HUTT CITY PROPOSED DISTRICT PLAN  
HEARING STREAM 5 – NATURAL  
HAZARDS

SUPPLEMENTARY  
COMMENTS OF  
DIETER ENGEL –  
PDP/475 - ON  
PROPOSED FLOOD  
REMODELLING  
PARAMETERS

10A Bloomfield Terrace, Lower Hutt

2 October 2026

**Figure 2 – Tiaki Wai flood-depth mapping for 10A Bloomfield Terrace showing the depth bands and the 0.5–1.0 m depth category affecting part of the property.**

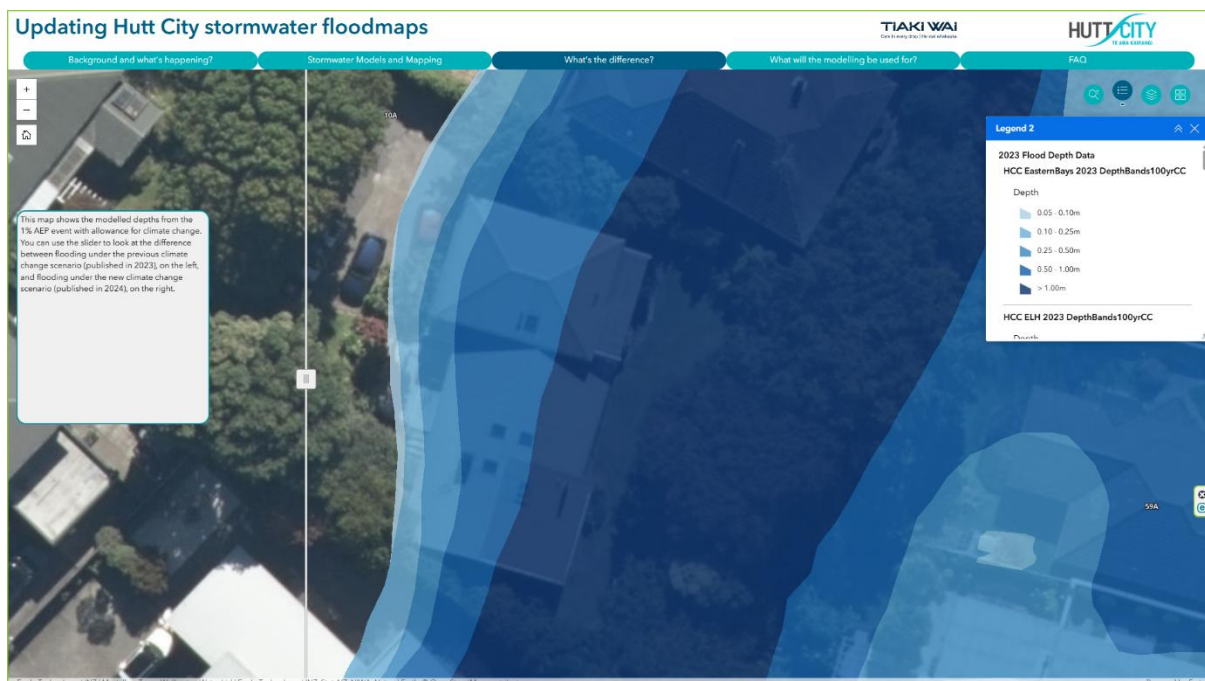
59. There is also a practical communication issue for property owners.
60. At 10A Bloomfield Terrace, Mr Engel and Mr Pattinson found it difficult to distinguish visually between the darker blue flood-depth bands on the online map.
61. It was necessary to interrogate the map digitally to establish that the darkest area affecting part of the property represented a modelled depth band of approximately **0.5–1.0 m** rather than the next depth category.
62. A flood-depth map is not, by itself, a complete expression of flood hazard. Flood hazard classification also depends on velocity and the relationship between depth and velocity.
63. The section 42A material confirms that the PDP classification process uses modelled depth, velocity and depth-velocity product. Section 42A report - Natural Ha...

65. However, a property owner looking only at the planning map and Definitions chapter cannot readily determine whether a particular classification arises from depth, velocity, depth-velocity product, stream-corridor identification, post-processing, or an additional freeboard process.

66. We request that the revised modelling outputs clearly distinguish and make available:

- modelled depth;
- modelled velocity;
- depth-velocity product;
- flood extent;
- hazard classification; and
- any separate freeboard or residual-risk allowance.

**Figure 4 – Approximate Opahu Stream/open-channel and piped drainage network: approximately 4.2 km upstream of 10A Bloomfield Terrace and approximately 2.4 km downstream to the Hutt River. Stormwater lateral drains feed into the trunk network throughout Hutt Central.**

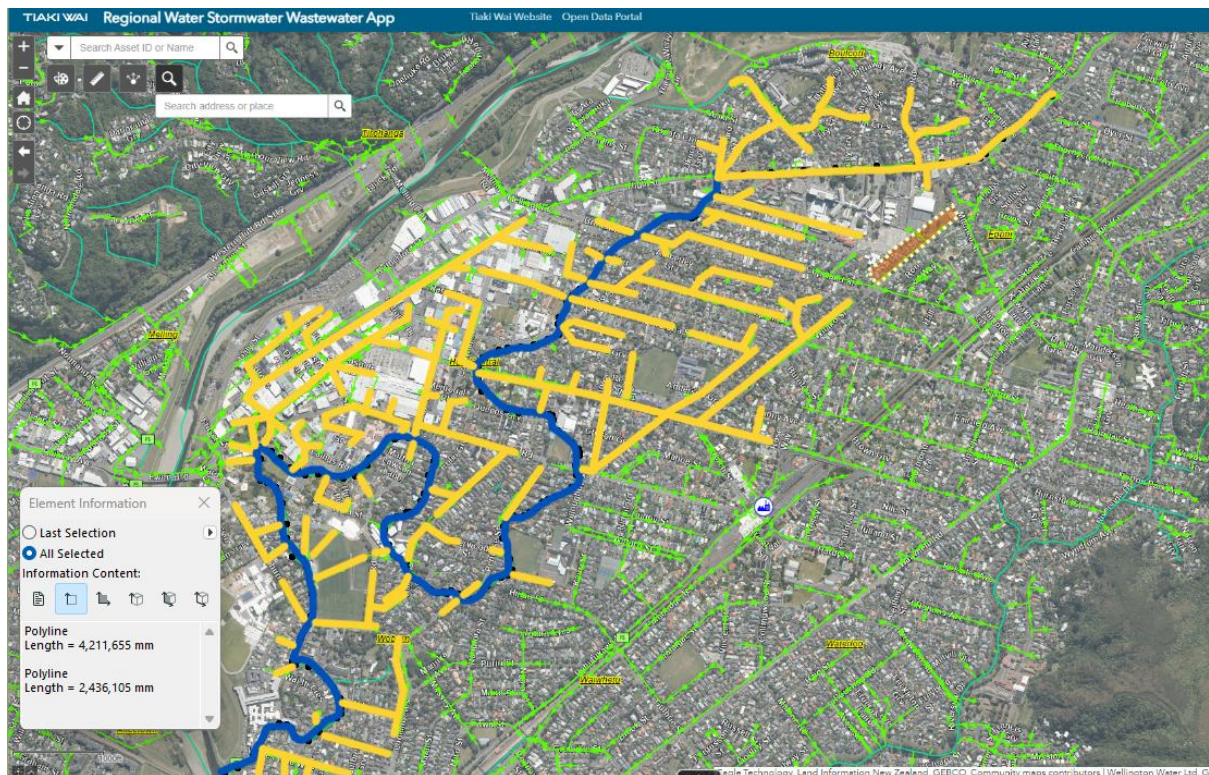
67. Mr Engel's property at 10A Bloomfield Terrace provides a practical example of why the representation of the existing urban catchment matters.
68. The property lies within the Opahu Stream/stormwater drainage catchment in Hutt Central.
69. Based on tracing of the public stormwater mapping, approximately **4.2 km of open and piped Opahu channel lies upstream of 10A Bloomfield Terrace**, with approximately another **2.4 km downstream** before discharge to the Hutt River.
70. A dense network of stormwater pipes and surface drainage routes feeds into this system from the surrounding urban area.
71. Accordingly, flood behaviour at 10A Bloomfield Terrace reflects the cumulative response of a highly modified urban catchment containing extensive impervious surfaces and a complex drainage network.

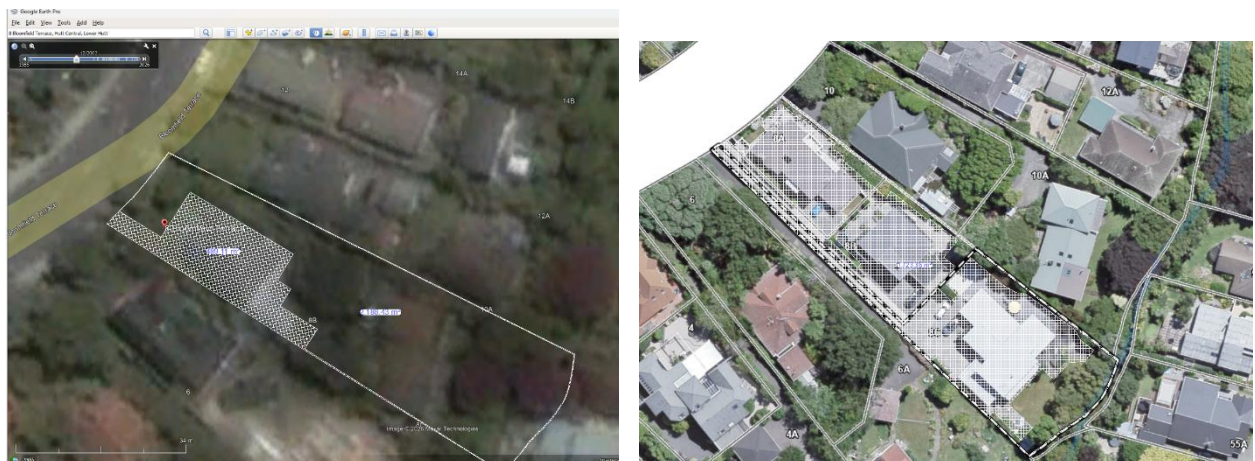
74. Historical aerial imagery from December 2002 indicates that the original site was approximately **22% impervious**, or about **490 m<sup>2</sup>**.

75. Following subdivision and subsequent development as 8A, 8B and 8C Bloomfield Terrace, the impervious area is now estimated at approximately **1,720 m<sup>2</sup>**, or approximately **79–80%** of the original site.

76. This represents an increase of approximately **1,230 m<sup>2</sup> of impervious surface**.
77. These figures are approximate measurements from aerial imagery, but the scale of change is sufficiently large to illustrate the hydrological issue.

78. Unless increased runoff from such redevelopment is detained, infiltrated or otherwise offset, increasing impervious area can increase the volume and/or rate of stormwater leaving a site.

79. We have not yet established whether hydraulic-neutrality or equivalent stormwater attenuation requirements applied to the March 2003 subdivision or subsequent dwelling developments. The relevant subdivision consent conditions and historic District Plan/engineering requirements are being obtained.
80. This historical example is not advanced as proof that the present flood model is incorrect.
81. Rather, it illustrates why the existing-condition model needs robust validation. Present-day flooding reflects the cumulative effects of decades of subdivision, paving, building, drainage connections and alterations to the urban catchment.
